**Re: Permit No. M-1980-244; Cripple Creek & Victor Gold Mining Company; Cresson Project;**  
**Technical Revision 140 – Third Adequacy Review Response**

On February 6, 2024, Newmont Corporation's Cripple Creek and Victor Gold Mining Company (CC&V) received the Division of Reclamation, Mining and Safety (DRMS) Third Adequacy Review of Technical Revision (TR) 140 to Permit M-1980-244, regarding the VLF2, Phase 3 Stage A.2 Record of Construction Report. Below are DRMS comments in bold and CC&V's responses in *italics*.

<b>NewFields</b>	CLIENT <b>CRIPPLE CREEK &amp; VICTOR GOLD MINING COMPANY</b>		
	PROJECT <b>VLF3 PHASE 3 STAGE A.2</b>		
TITLE	<b>LEAK DETECTION TRENCH 2 AS-BUILT PLAN AND PROFILE (2 OF 2)</b>		FILENAME
			0106.060.064F
	FIGURE NO.	REVISION	
	<b>6B</b>	<b>2</b>

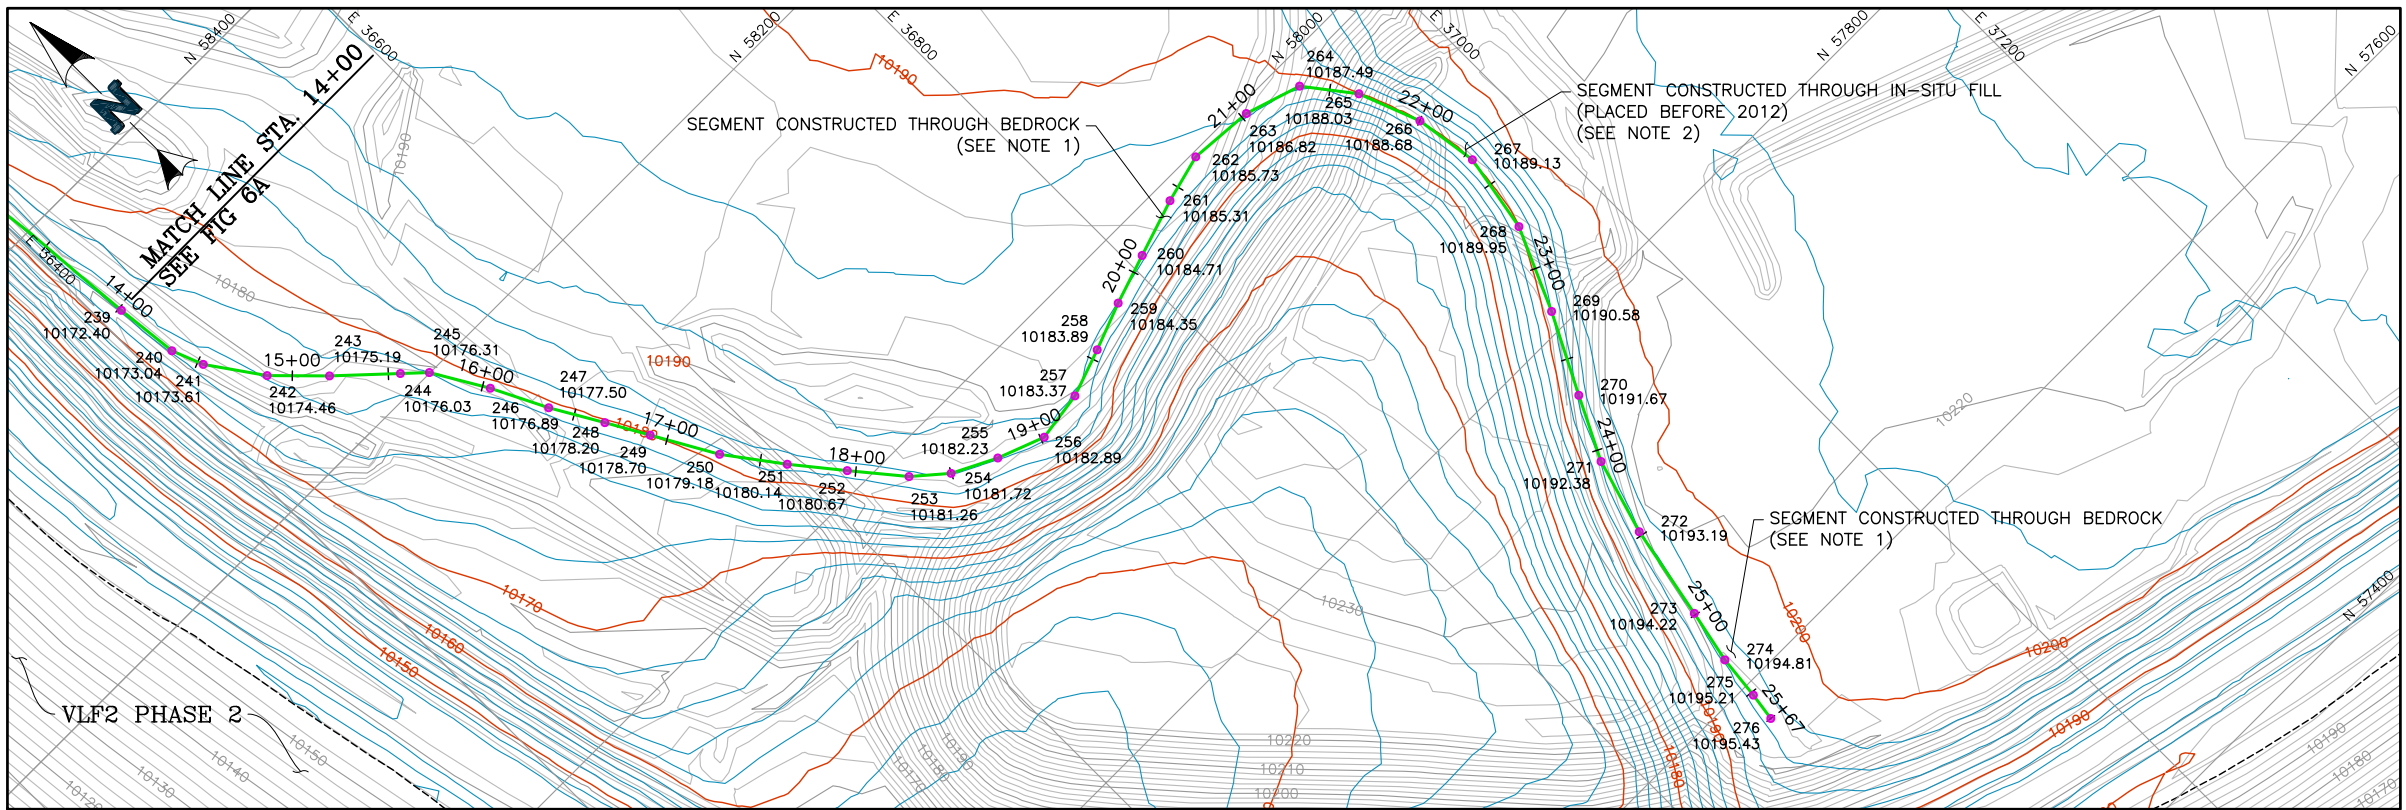
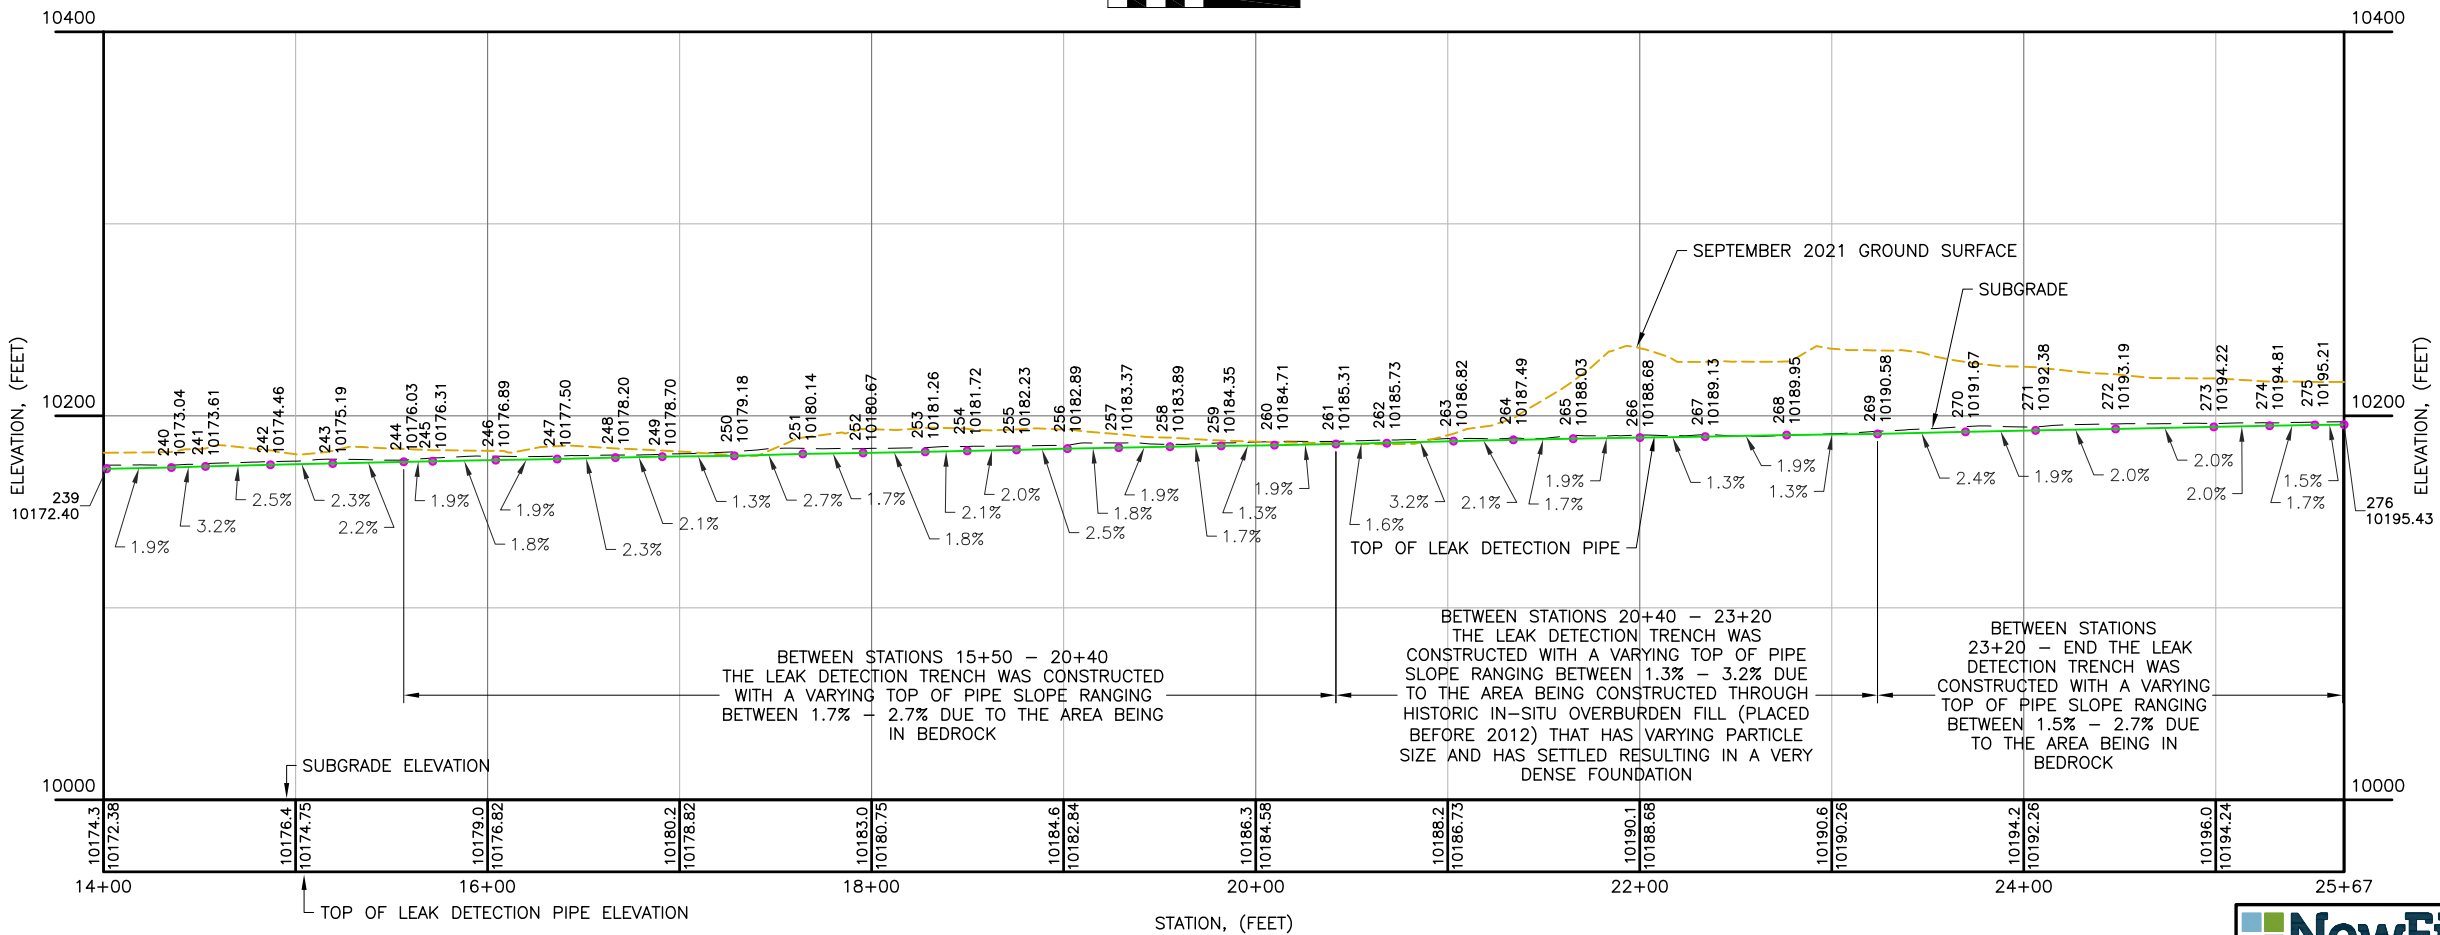
The Division asked for the slope indicator labels to be moved to the profile view as is standard civil engineering practice. Instead, the font size of the slope indicators in the plan view was slightly increased but is still obscured by crisscrossing topography contours. The Division also asked for segments (*i.e., beginning and ending stations; STA X+XX to STA Y+YY*) not meeting the 2% slope criteria and why (e.g., *was constructed at a ZZ% slope due to \_\_\_\_ field conditions*) also be provided in the profile view. None of this information was moved to or expanded upon in the profile view. As such, only incomplete and illegible information has been provided to explain why deviations to the approved drawings and specifications were allowed by the approving engineer. This required information is for the public record. As such it must be thorough and legible. Therefore, as a condition to approving TR-140, the Division is now requiring standard civil engineering practice be followed on Figures 5 and 6 cited in the Deviations section of the CQA report to explain deviations to the approved designs and specifications. This includes the following:

- Slope indicators must be shown in the Profile Views on Figures 5 and 6.
- Beginning and ending stations where the 2% minimum slope was not adhered to, must be identified in the Profile View on Figures 5 and 6.
- The rationale for these segments of the Leak Detection System needing not meet approved drawings and specifications must clearly be directed at these specific segments either by a note with a leader specifying the beginning and ending stations or a note in the Profile View over the specific segments explaining why the approved grades were not met.

*Enclosed as Attachments 3-5, Figures 5, 6a and 6b have been revised to include the location of the survey points, slopes, and an explanation for the reason why the minimum slope of less than 2% was allowed with the corresponding stationing in the profile view as requested.*

- SEGMENT CONSTRUCTED THROUGH BEDROCK/PIT-HIGHWALL. METHODS NECESSARY FOR FURTHER EXCAVATION, SUCH AS BLASTING, WOULD BE LESS PRECISE AND ULTIMATELY DETRIMENTAL TO THE PROJECT. SETTLEMENT IN THESE AREAS IS UNLIKELY.
- SEGMENT CONSTRUCTED THROUGH IN-SITU FILL PLACED BEFORE 2012. SETTLEMENT IN THESE AREAS IS UNLIKELY.
- OVERALL SLOPE OF UPPER LEAK DETECTION TRENCH IS 2.0%.
